Review of Safety Guide on Deterministic Safety Analysis for NPPs (DS491)

Table of Member States comments Resolutions

6 April 2017

Figure 1 (Jordan)

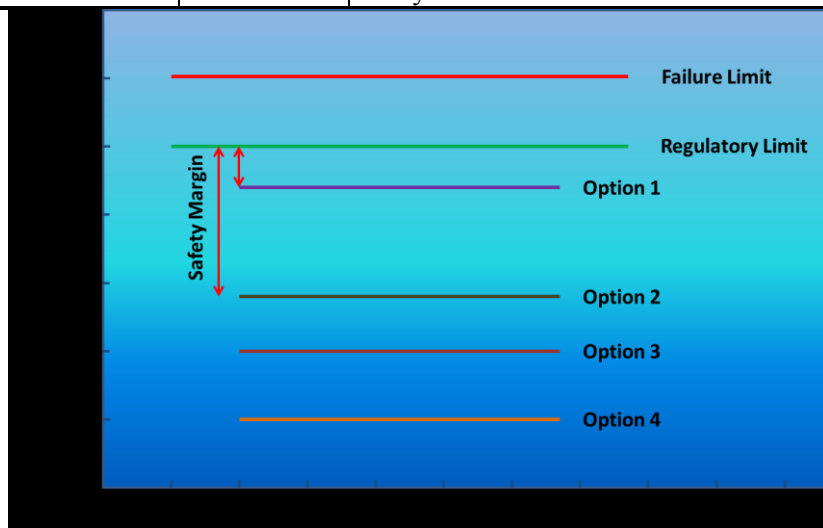
COMMENTS BY REVIEWER				RESOLUTION			
Comment Nr	Para / Line Nr.	Proposed new text	Reason	Accepted	Accepted, but modified as follows	Rejected	Reason for modification/rejection
		level of confidence in the conclusions. Availability of systems...”			initial and boundary conditions may be used taking into account the very low probability that all parameters would be at their most detrimental value at the same time. However, ...”		
IAEA/WES-5 (Unsolicited)	2.12 Last sentence	“...Option 3 ... is at present accepted for some design basis accidents and for conservative analyses of anticipated operational occurrences”	Editorial.	X			
Jordan 1	2.14	It is suggested to add a figure (e.g. see Figure 1) to illustrate the decreasing level of conservatism from options 1 to 4.	In order to illustrate the decreasing level of conservatism from options 1 to 4			X	(Note: see Fig 1 at the end of this Table). Proposed illustration seems not necessary. Table 1 seems enough.

Figure 2 (Jordan)

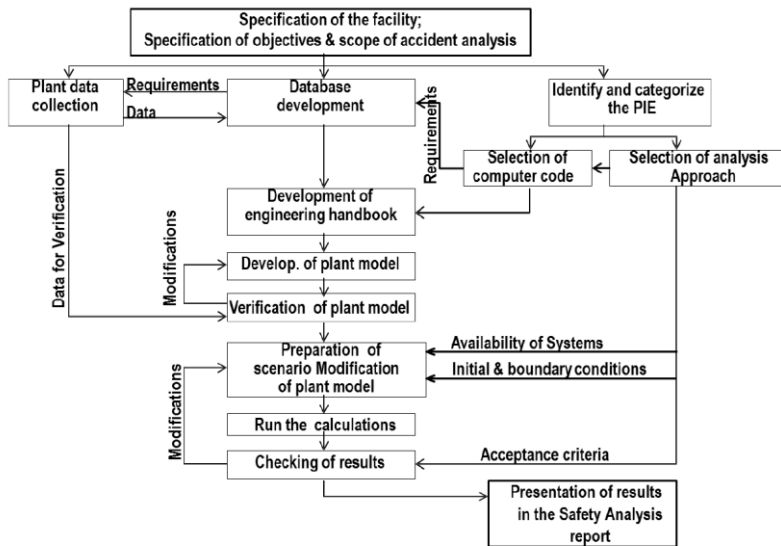
COMMENTS BY REVIEWER				RESOLUTION			
Comment Nr	Para / Line Nr.	Proposed new text	Reason	Accepted	Accepted, but modified as follows	Rejected	Reason for modification/rejection
		on emergency response that are required to protect human life, health, property and the environment in case of an emergency at the NPP which were installed in IAEA requirements and recommendations (GSR part 7 [9], GS-G-2.1 [10], GSG-2 [11])”.	2.1 and, GSG-2.				safety standards mentioned are indicated in the footnote (3).
Turkey 15	2.19	The paragraph is suggested to be removed.	The paragraph does not provide any additional information.			X	As the para. seems convenient for other reviewers it is left untouched.
Jordan 2	New 2.20 (or after section 8)	<p>Suggestion to insert section 2.20 or a Section after section 8 to identify or summarize the procedure used in this document describing how to perform deterministic Safety analysis.</p> <p>The proposed procedure as concluded from the document:</p> <ol style="list-style-type: none"> 1. Identify and categorize initiating events. 2. Establish acceptance criteria. 3. Establish the analysis approach and select the proper computer code. 4. Develop the plant model. 5. Perform the analysis. 6. Compare the results with the relevant acceptance criteria. <p>In addition, It is proposed to add a</p>	To identify or summarize the procedure used in this document describing how to perform deterministic Safety analysis		<p><i>The last part of para. 1.16 will be modified as follows:</i></p> <p>“...other sections of this Safety Guide; the sequence of these sections corresponds to the general approach, in terms of process, to perform deterministic safety analysis.”</p> <p><i>(Note: see Fig 2 at the end of this Table).</i></p>

COMMENTS BY REVIEWER				RESOLUTION			
Comment Nr	Para / Line Nr.	Proposed new text	Reason	Accepted	Accepted, but modified as follows	Rejected	Reason for modification/rejection
		figure to illustrate this procedure (e.g. see Figure 2).					
Section 3							
Russia 1 Comment 8	Title Section 3 and Contents	3. IDENTIFICATION GROUPING AND CATEGORIZATION OF POSTULATED INITIATING EVENTS AND ACCIDENT SCENARIOS	This addition of a term from the current version of a document more correctly reflects the content and purpose of this Chapter		IDENTIFICATION, AND CATEGORIZATION AND GROUPING OF PIEs AND ACCIDENT SCENARIOS (See para. 1.17)		
Russia 1 Comment 9		Postulated initiating event (PIE) – it is a single failures of elements, or multiple failures of safety system elements, including common cause failures, which initiation in conditions of defense –in- depth specific level leads to transition into conditions of following level of defense –in- depth.	Taking into account targets of deterministic safety analysis which are enumerated in section 3 it is offered new term for postulated initiating event.			X	Postulated initiating event (PIE) is defined in the IAEA Safety Glossary (see “initiating event”)

Figure 3 (Jordan)

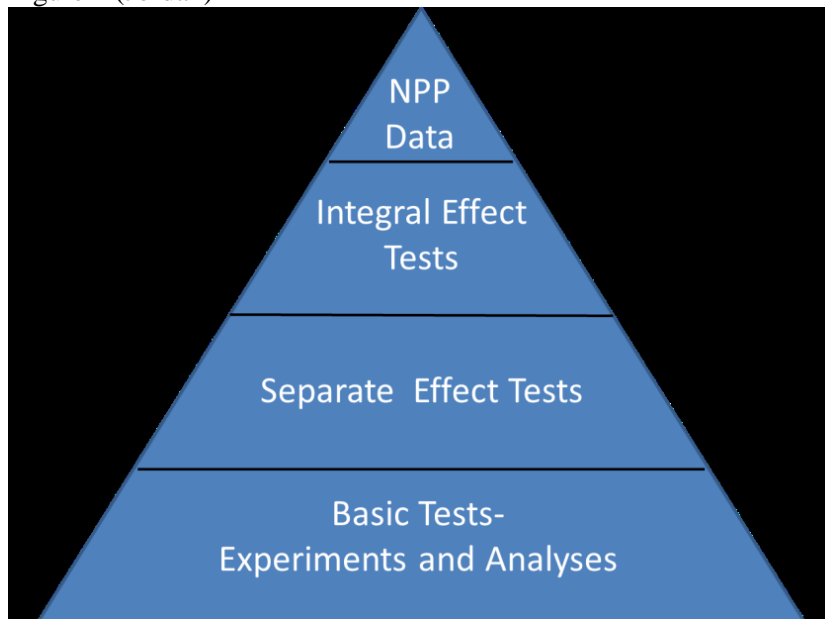
COMMENTS BY REVIEWER				RESOLUTION			
Comment Nr	Para / Line Nr.	Proposed new text	Reason	Accepted	Accepted, but modified as follows	Rejected	Reason for modification/rejection
Jordan 10	5.25 Page 29	It is suggested to add a figure (e.g. see Figure 3) to illustrate the hierarchy of experiments in the validation matrix. <i>(Note: See Figure 3 at the end of this Table)</i>	To illustrate that the required number of tests would decrease as the hierarchy moves from the basic and separate effect tests up to integral effect tests and plant operational data.			X	The use of figures is not a frequent practice in the Safety Guides and in this case it seems not necessary. Hierarchy in para. 5.25 can be implied by the structure (consecutive numbering) of the experiments.
France 15	5.30 Last sentence	“... The effects of phenomena that are not correctly represented should be addressed in other ways- with a sufficient level of conservatism.”	It is important to take into account phenomena not correctly represented in a sufficiently conservative way	X	<i>The last sentence of 5.30 will be modified as follows:</i> “... The effects of phenomena that are not properly correctly represented should be addressed in other ways- taking into account the applicable level of conservatism.”
